PITT STREET SOUTH
OVER STATION
DEVELOPMENT

SUBMISSIONS REPORT

Figure 8 – Three contemplated construction scenarios in relation to construction of the integrated station development

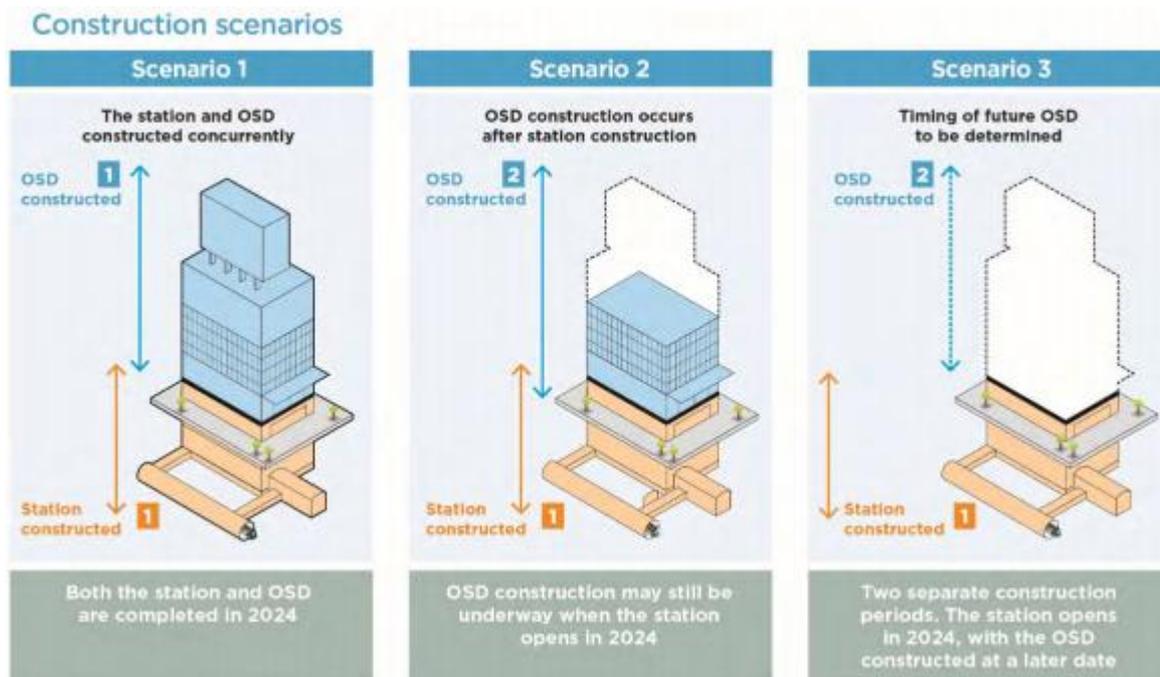
Of the above, Council's issue pertains to Scenarios 2 and 3. Council asserts that by contemplating these scenarios, Sydney Metro is confirming that there would be an adequate degree of flexibility in the program to allow for the undertaking of a design competition in accordance with the *City of Sydney Competitive Design Policy*.

This is not the case. It is stated throughout the EIS and Construction Management Statement that "Scenario 1 represents Sydney Metro's preferred option as it would provide for completion of the full integrated station development and therefore the optimum public benefit at the site at the earliest date possible (i.e. on or near 2024 when the station is operational)". Additionally, one of the key objectives of this concept SSD Application is to "provide the opportunity to deliver the OSD as early as possible with the aim of opening concurrently or shortly following completion of the Pitt Street Metro Station".

It is Sydney Metro's strong preference for Scenario 1 to be pursued, rather than Scenario 2 or Scenario 3. Scenario 1 is preferred because of the unique timing constraints of the Sydney Metro project, and to ensure the delivery of optimum public benefits. In the case of Scenario 1, the full scope of the Sydney Metro project integrated station development would be delivered concurrently, which would provide passengers with a world class metro experience which is not inhibited by construction of the OSD.

The above consideration of Scenarios 2 and 3 by Sydney Metro is necessary from an impact analysis perspective. Sydney Metro notes Scenario 1 as the preferred option, but has considered alternate scenarios to ensure that, in the event the OSD is delayed, a framework would continue to exist to ensure that no adverse impacts arise from the delayed construction. This is an appropriate response, given that external impacts outside of Sydney Metro's control could inhibit the ability for Scenario 1 to be achieved.
